# SERVICE BULLETIN No.1167

<b>COACH MODEL</b>	: T2145 and C2045
<b>BULLETIN TYPE</b>	: Field Change Program
<b>MANUAL &amp; SECTION</b>	: N/A
<b>MANUAL REVISION</b>	: No
<b>DATE</b>	: June 28, 2005
<b>SUBJECT</b>	: <b>Condenser fan relay wiring</b>
<b>TERMS &amp; CONDITIONS</b>	: Refer to the Warranty Information in this Bulletin.

**Figure 1: Carrier/Sütrak wiring loom**

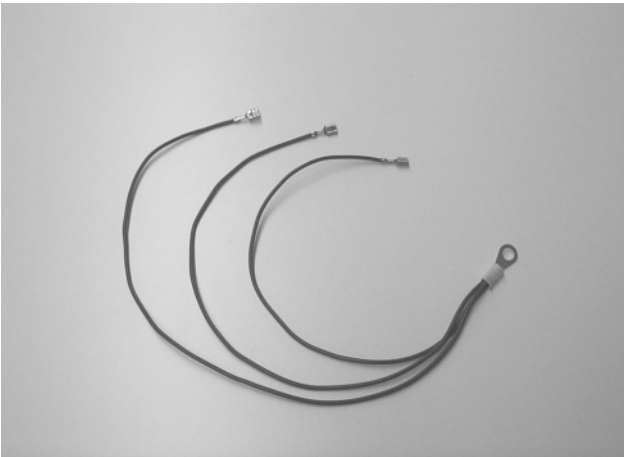
- Carrier/Sûtrak, manufacturers of the Sytronic HVAC switchboard used on T- and C-model coaches, have informed Van Hool that because of manufacturing inconsistency the terminal #87 (ground) wiring of relay sockets #K26M, #K24M and #K22M may have been improperly crimped.
- To improve the reliability of the system and avoid possible shorts, the above-mentioned relay socket ground wiring should be replaced by a dedicated wiring loom.
- Refer to the procedure on page 2/6 of this Bulletin for repair instructions.
- Information on parts supply and labor allowance is provided on page 5/6.

<b>Part No.</b>	<b>Description</b>	<b>Qty.</b>
VH 10962304	Wiring loom, Carrier 63.50.20.030	1

**Figure 4: Switchboard ground stud**

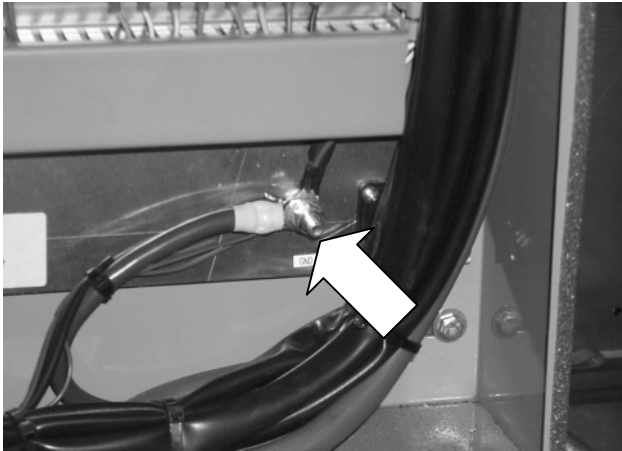
- 6) Undo and remove the nut securing the relay ground wires to the junction box back plate (see Figure 4).  
Remove relay #K26M, #K24M and #K22M terminal #87 ground wires.

- 7) Install the female blade terminals of wiring loom VH 10962304 in the now vacant #87 slots in the #K26M, #K24M and #K22M relay sockets respectively.  
Hook-up the ring terminal to the switch panel ground stud.  
Secure with the M8 nut. Tightening torque: 15 ft.lbf (20 Nm).
- 8) Reinstall #K26M, #K24M and #K22M relays into their respective sockets.
- 9) Attach the relay bank to the switchboard back plate with the sheet metal screws.
- 10) Reinstall relays #K3A, #K23M and #K28M.
- 11) Reinstall the lower cable duct guard.
- 12) Close the HVAC junction box.
